☆ AS BUILT CHANGES 5-11-90

SR 90
3RD LAKE WASHINGTON FLOATING BR.
APPROACHES AND TRANSITION SPANS
ALTERNATE A2

CROSS SECTIONS

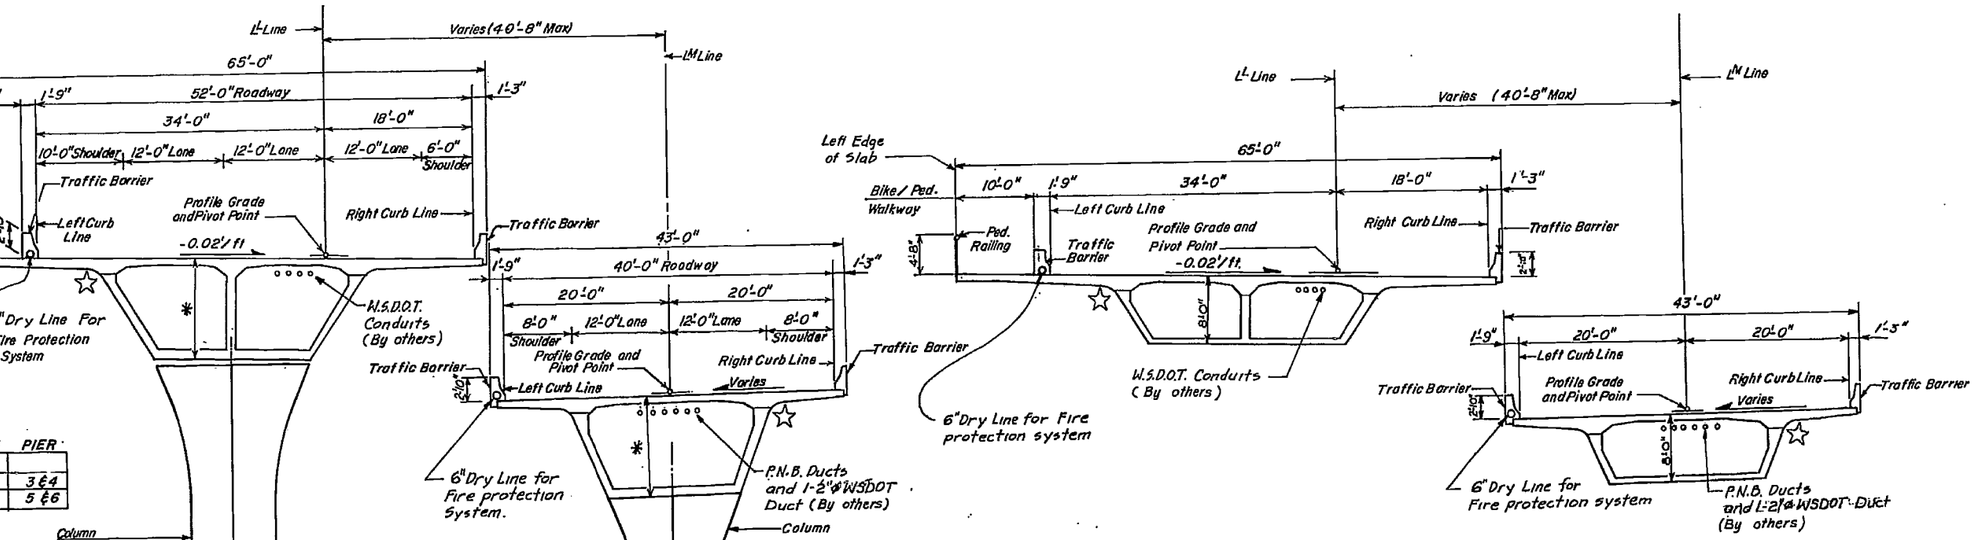
NOTE:
☆ CONSTRUCTION JOINTS AT THE TOP OF WEBS IN THE PIER TABLES & C.O.F. SPANS HAVE EXTRA VERTICAL P.T., ADDED REBAR, ROUGHED SURFACE, & WERE EPOXY COATED JUST PRIOR TO SLAB POURS. SEE CHANGE ORDER 156.
